Architectural Review Board Meeting Agenda

Thursday, February 29, 2024 at 5:30 p.m.
City of Carpinteria, Council Chamber
5775 Carpinteria Avenue, Carpinteria, CA 93013

1. Project: Carpinteria Business Park Landscape and Hardscape Improvements
Project 23-2257-DPR/CDP
Address: 4185 – 4198 Carpinteria Avenue
Applicant: Sam Maphis, Landscape Architect, for
Carpinteria Business Park Partners
Planner: Brian Banks

Project: 23-2257-DPR/CDP **Planner:** Brian Banks
Address: 4185 – 4198 Carpinteria Avenue
APN: 004-031-017, -018 and -019
Zoning: Commercial Planned Development with Residential Overlay (CPD/R)
Applicant: Sam Maphis, Landscape Architect, for Carpinteria Business Park Partners, owners

B STONE BORDER WALL
Scale: 1/2" = 1'-0"

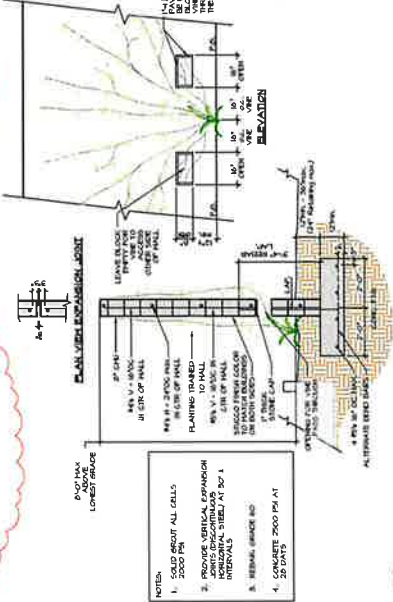
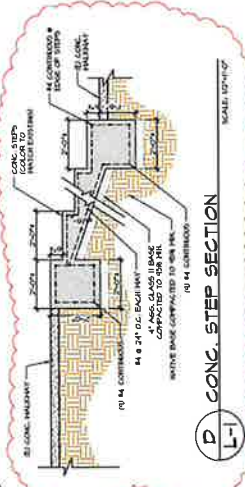
- Proposed patio wall details; and
- Proposed freeway wall notches for vine plantings.

- provide details on patio wall pattern and design
- incorporate notches into freeway wall to allow vine to cover freeway side of wall in addition to property side of wall.
- confirm if path lighting is required for safety and if so, provide lighting details on final plans.

While it is not certain that path lighting is necessary for pedestrian safety, the lighting details are provided in the event they are deemed necessary and to ensure the lighting is part of the approved project description and final plans. Staff believes that the revised project plans have satisfactorily addressed the ARB's previous comments, and all necessary plan details for final ARB review have been provided.

PRELIMINARY LANDSCAPE LIGHTING PLAN

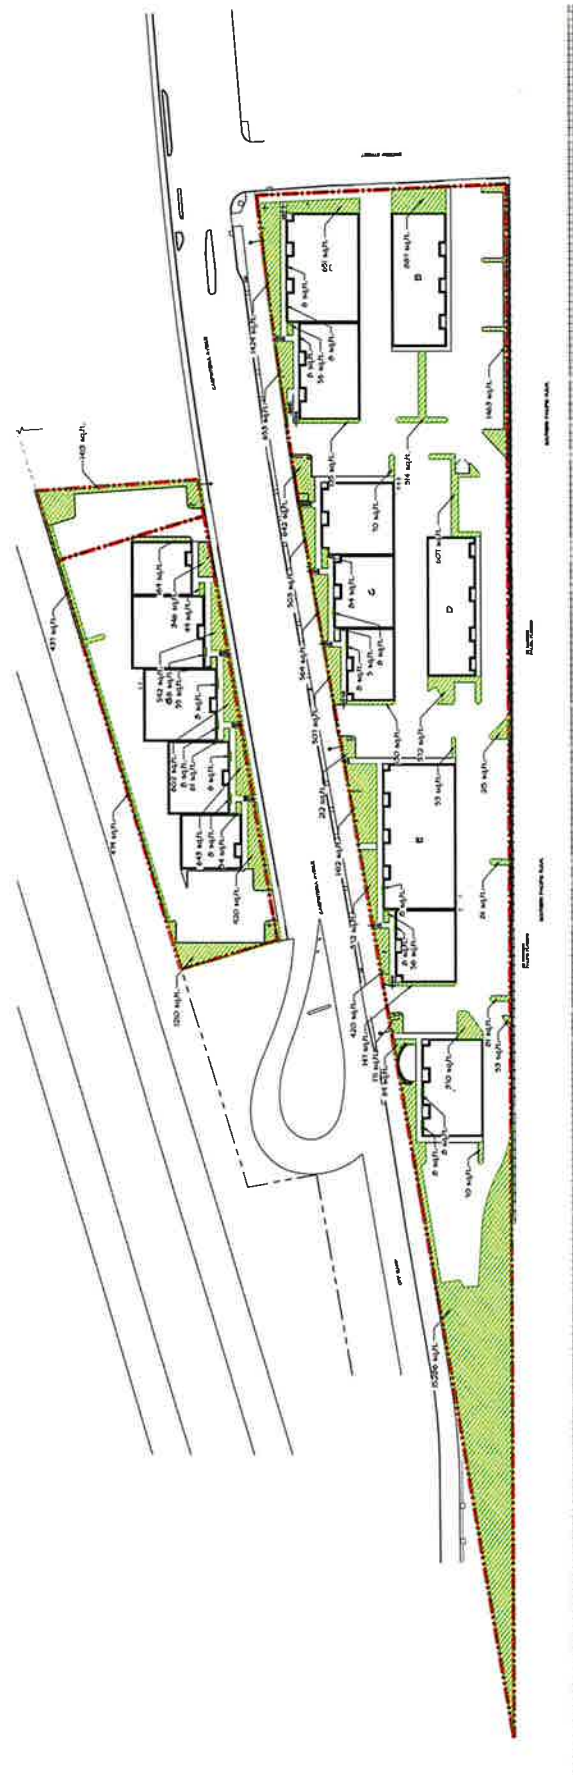
Boardmember Blakemore questioned if any path lighting is proposed and Mr. Maphis clarified that no lighting is proposed and will study to confirm that existing lighting is sufficient by code for safety of pedestrians. Boardmember Blakemore also wanted to confirm no clean up or plant removal is proposed to the west “triangle” along the railroad tracks, which was confirmed by Mr. Maphis and Staff.

EXISTING:
6'-1 1/4" X 12'-5" MID-RISE SIGN
BOXED AREA: 75.80 SQ FT

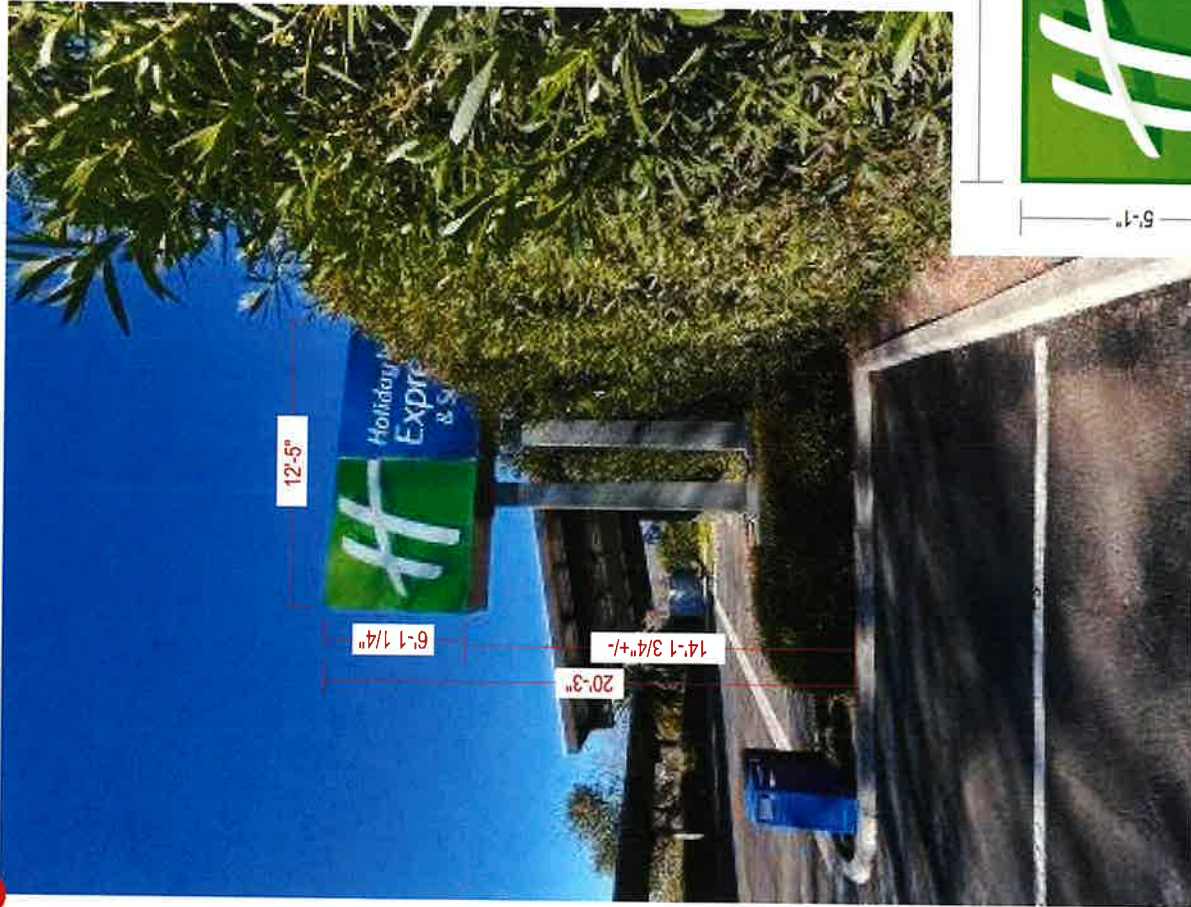
The Board's comments on the proposed revised sign design, appropriateness to the site, and harmonization with the building and surrounding area is requested.

- Proposed revised sign design, materials, colors and lighting;
- Modification request for the pole sign replacement and height increase, and required findings;
- Relationship of proposed signage standards to individual building architecture/identity; and
- Overall compatibility with surrounding development and "small beach town" image.
